Access Compliance Report Public Rights-of-Way (RR Crossings)

Intersection ID: 32449	Main Street: N_TRYON_ST	Location: N/A
ADA ID: 656F21788D1F	Overall Compliance: No	Severity Score: 0.0
Codes/Mitigation Info/Possible Solution		Field Measurements/Component Compliance

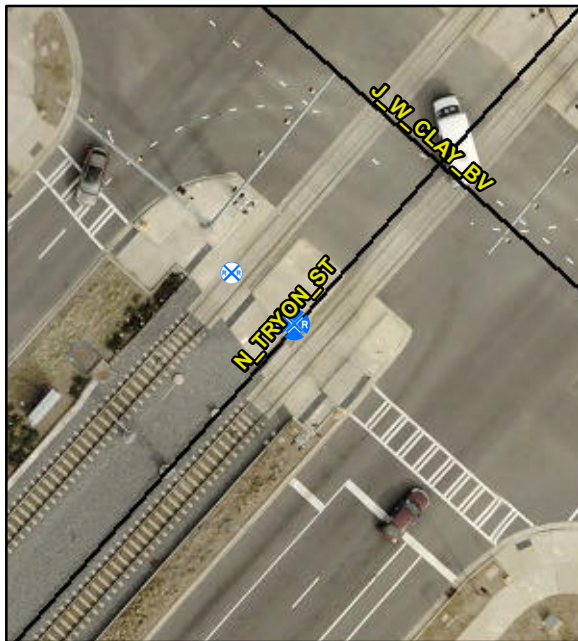
Compliance	Description	Data
Yes	DWS Provided?	Yes
Yes	DWS Contrast?	Yes
Yes	DWS Width (in)	Yes
Yes	DWS Length (in)	24.0
Yes	DWS Offset (in)	113.0
Yes	Pedestrian Gate?	Yes
N/A	DWS Outside Gate?	No
N/A	Rail Type?	LightRail
No	Flangeway Gap (in)	2.5
Yes	Sidewalk Width (in)	121.0

**Remove & Replace Detectable
Warning System. Remove & Replace
Walking Surface Adjacent to Rail.**
